SUBMISSION ON THE DEVELOPMENT APPLICATION FOR JOHN GORTON DRIVE STAGE 3C (DA 202037798)

The Public Transport Association of Canberra (PTCBR) would like to express its profound concern with the proposed design of the final stage of John Gorton Drive (Stage 3C).

Figure 1 - John Gorton Drive Stage 3C Intersections – Molonglo Town Centre (left) and Whitlam (right)

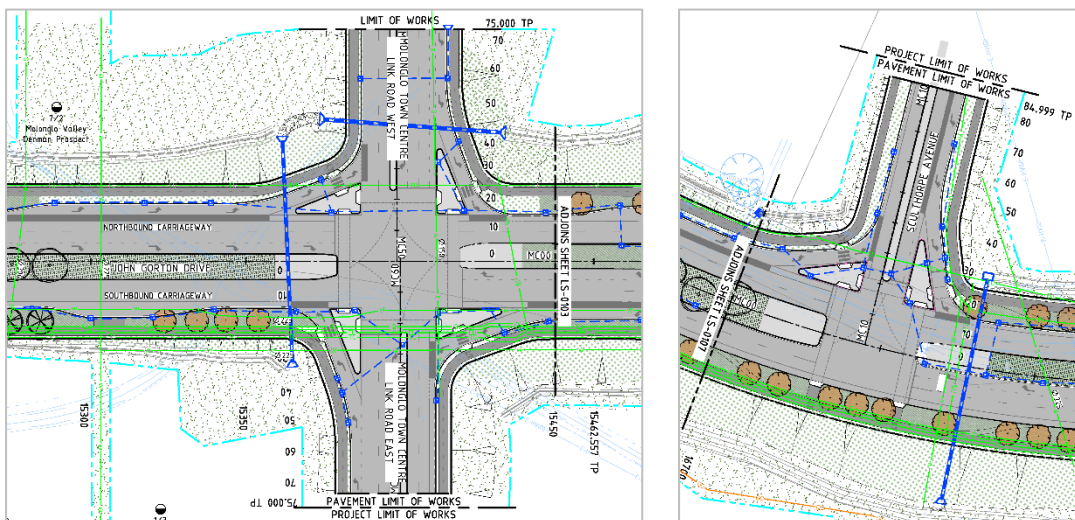
- The proposed designs of the new intersections included in John Gorton Drive Stage 3C (John Gorton Drive/Sculthorpe Avenue and John Gorton Drive/Molonglo Town Centre Link Roads East and West) do not include public transport priority measures. This is shown in [Figure 1](#).

- In attempting to justify this deliberate omission, Jacobs Engineering Group (the consultants) appear to have either misunderstood or misrepresented the extent and purpose of the public transport priority measures that have been incorporated into the existing stages of John Gorton Drive.

- This is best illustrated by the consultants' claim that public transport priority measures are not needed for John Gorton Drive Stage 3C, as they were not included in Stages 2A or 3B:

1. The intersections featured in John Gorton Drive Stage 3C should be modified to include public transport priority measures consistent with the design of John Gorton Drive Stages 1 and 2A.
2. The section of John Gorton Drive Stage 3C adjacent to the Molonglo Group/Town Centre should continue the established urban design character of John Gorton Drive Stage 2A.

Figure 2 - John Gorton Drive Stage 2A Public Transport Priority Measures

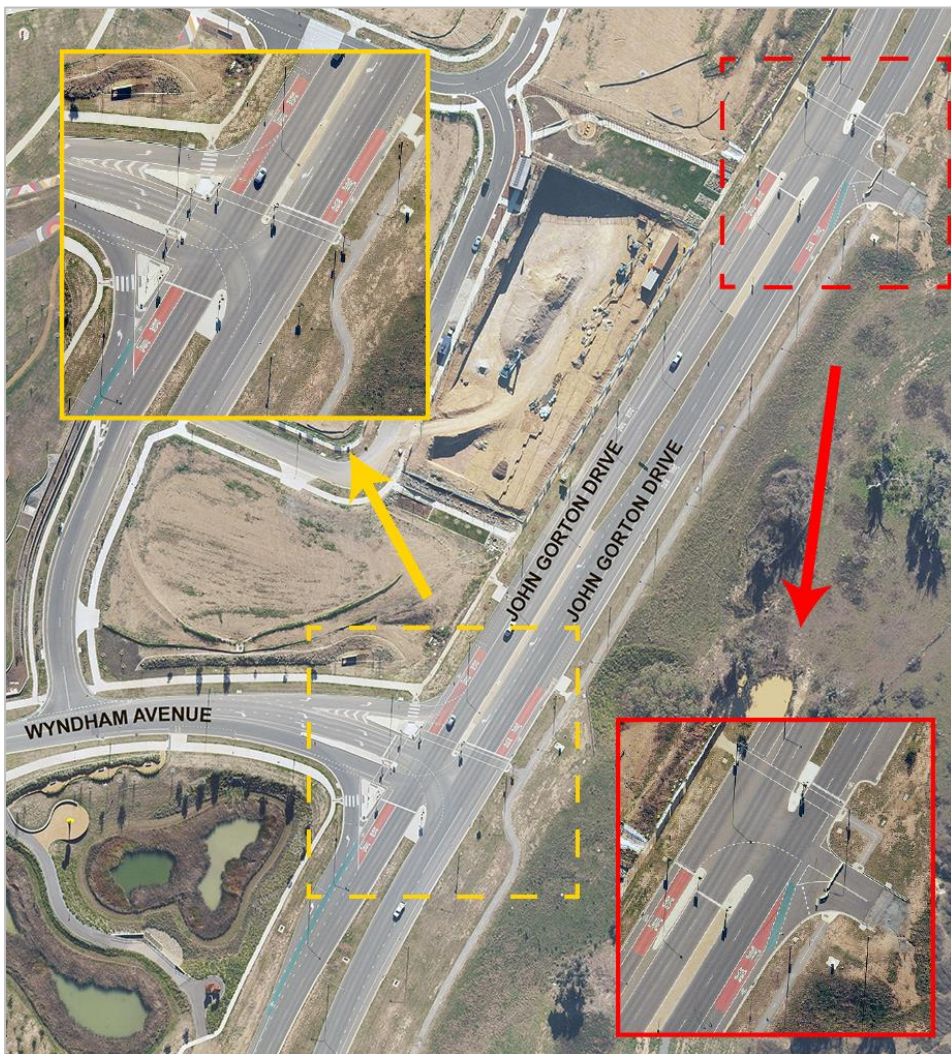
- It is factually incorrect to state that there are no public transport priority measures included in John Gorton Drive Stage 2A.
- A cursory examination reveals that a number of public transport priority measures have been incorporated into John Gorton Drive Stage 2A. These are shown in [Figure 2](#).

- These measures have been designed to facilitate the diversion of the future rapid public transport corridor off John Gorton Drive to connect with a transport interchange embedded in the Molonglo Valley Group/Town Centre.¹
- This intention is described below and illustrated in [Figure 3](#) and [Appendix B](#).

Figure 3 - Molonglo Valley Stage 2 Planning and Design Framework - Public Transport Plan

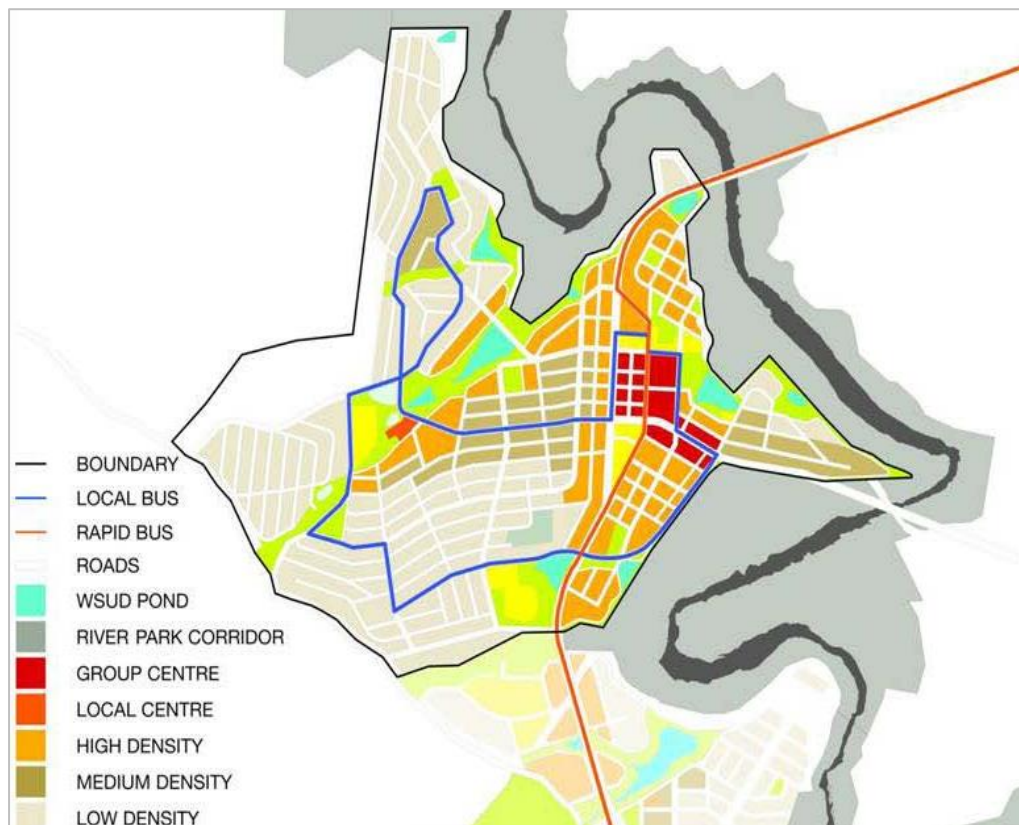
“Dedicated bus lanes are provided along JGDE [Stage 2A] between Pond Road [Wyndham Avenue] and Commercial Street to facilitate access to the Group Centre via Commercial Street. Bus priority measures are provided at the following intersections on JGDE [Stage 2A]:

Figure 6 - Stage 3C intersection modifications required to facilitate future light rail

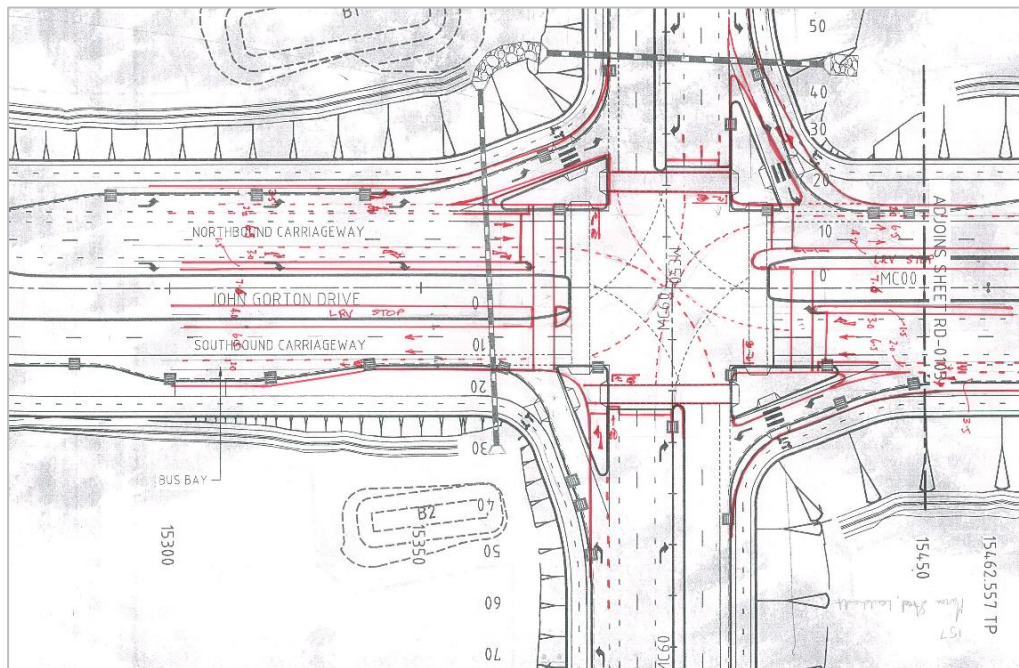
- The required changes were illustrated in the *John Gorton Drive Bridge and Road Construction Works - PSP Third Party Peer Review (WSP, 2020)* and are reproduced in [Figure 6](#).⁶

- It is PTCBR’s considered view that future complications associated with as-yet unfunded proposals for a hypothetical light rail corridor are not a sufficient reason to justify the denial of fast, frequent, reliable and safe public transport outcomes for residents of Molonglo for up to two decades, especially when such complications will inevitably be encountered regardless of whether public transport priority measures are included in the original build.
- This reasoning therefore should not be accepted as an adequate justification for the absence of public transport priority measures in Stage 3C.

Figure 7 - Typical Intersection for John Gorton Drive – Recommended (top) and Delivered (bottom)

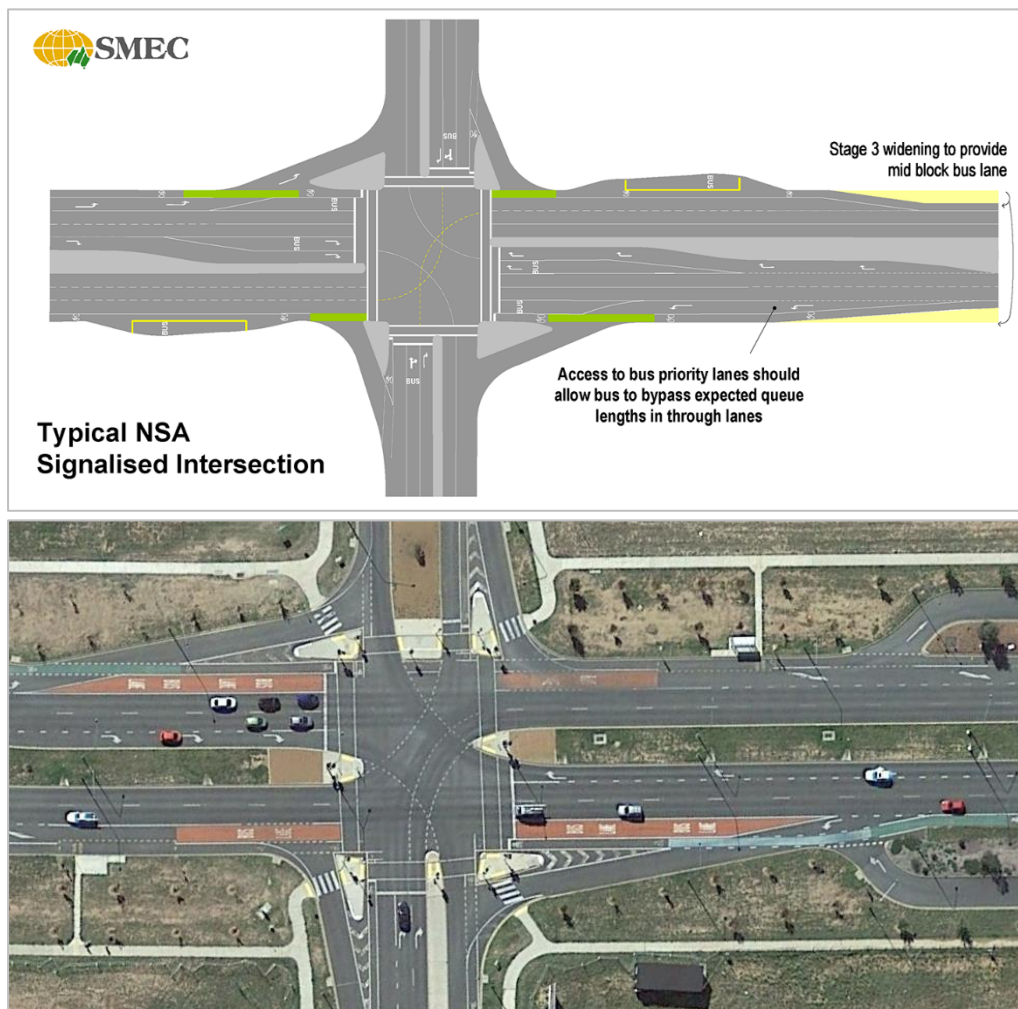
- This is consistent with the recommendations of the *ACT Strategic Public Transport Network Plan* (McCormickRankinCagney, 2009) and the *Molonglo Roads Feasibility Study* (SMEC, 2008) as outlined below and illustrated in [Figure 7](#).⁹

“On the North-South Arterial, Rapid buses can operate in a kerbside lane with these features:

- *The lane is designed so that it can be made bus-only on approach to signals, with a queue bypass at the signal.*
- *The lane is identified in policy as one that can be converted to bus-only if/when operating speed standards require it.*
- *A pocket lane for left-turning traffic is provided on the near-side of intersections, so that queuing left-turning traffic does not block the bus. The length of this pocket should depend on modelling of turning movements at the intersection.”*

- The *ACT Strategic Public Transport Network Plan* explains that this arrangement is necessary to protect the speed and reliability of vehicles operating along the Molonglo IPT corridor,¹⁰ with the presence of reserved lanes at intersections being identified as the “minimal requirement for effective operation” of the corridor.¹¹

- As this outcome is clearly contrary to established ACT Government transport objectives to encourage sustainable transport use, the proposed design for Stage 3C should be modified to include public transport priority measures.

Figure 9 - John Gorton Drive Group/Town Centre Interface - Cross Section

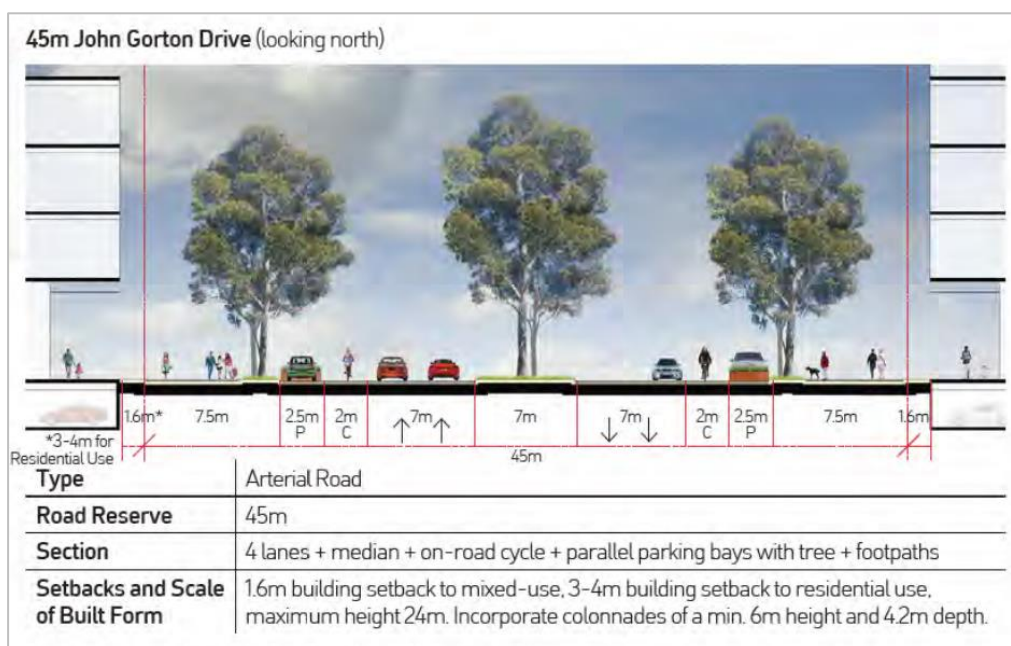
- The reasoning behind the inclusion of these features is articulated in the *Molonglo Valley Stage 2 Group Centre and Environs Planning and Design Framework – Urban Design Component* report, as reproduced below and illustrated in [Figure 9](#).¹⁵

- These features are consistent with the ACT Government’s *Movement and Place Framework* as outlined in the *ACT Planning Strategy 2018*, which seeks to balance the dual function of streets of moving people and goods and enhancing the places they connect and pass through.¹⁶
- None of these features are included in the section of John Gorton Drive Stage 3C adjacent to the future Molonglo Town/Group Centre, located south of the John Gorton Drive/Molonglo Town Centre Link Roads intersection.
- To ensure consistency with the established character of John Gorton Drive Stage 2A and the ACT Planning Strategy’s *Movement and Place Framework*, the section of John Gorton Drive Stage 3C adjacent to the future Molonglo Town/Group Centre should retain the use of smart/multi poles, parallel parking bays with landscaped blisters and the narrower 7 metre median.
